TECHNICAL BULLETIN

Air Springs

LIT NO: L1155

Revision: A

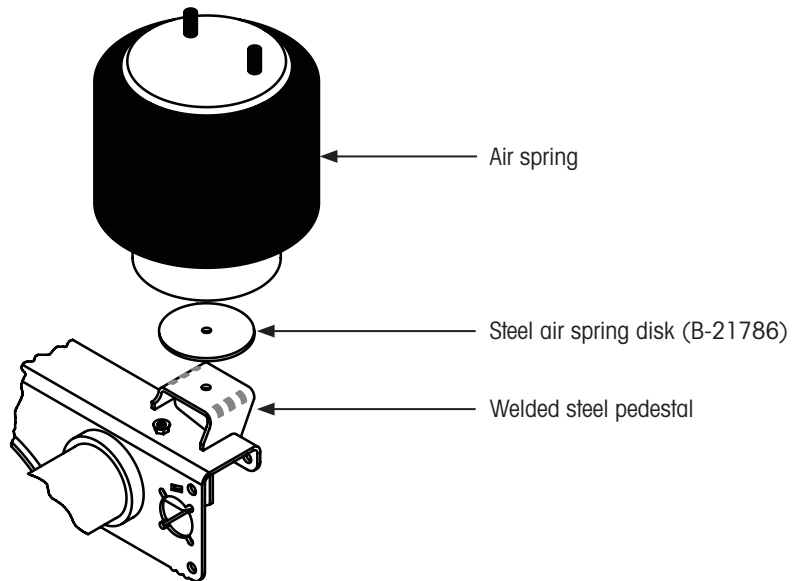
Hendrickson Trailer Suspension Systems will be superseding the S-21784 (AAT 25K), S-27341 (AAT 30K) and S-24443 (HKA 50K) air springs to the S-20901, S-25873 and S-23748 air springs respectively, beginning April 2010.

Currently all three aftermarket replacement air spring kits (S-21784, S-27341, S-24443) include the air spring and a steel air spring disk (B-21786). The B-21786 steel air spring disk is included on the original equipment suspension and can be re-used when replacing the air spring. Therefore, the steel disk will no longer be included in the aftermarket kit.

Please note the B-21786 steel air spring disk is **still required** when replacing the air spring if originally equipped with the disc. As previously stated, you can re-use the steel disk from the air spring being replaced. If a new steel air spring disk is required please order the aftermarket equivalent, part number S-21786. Please refer to the chart below for further clarification.

1. AAT suspensions with bolt-on pedestals **do not** require the steel air spring disc. Reference T19001 (Wide Pivot LDA Axle Component Changes).
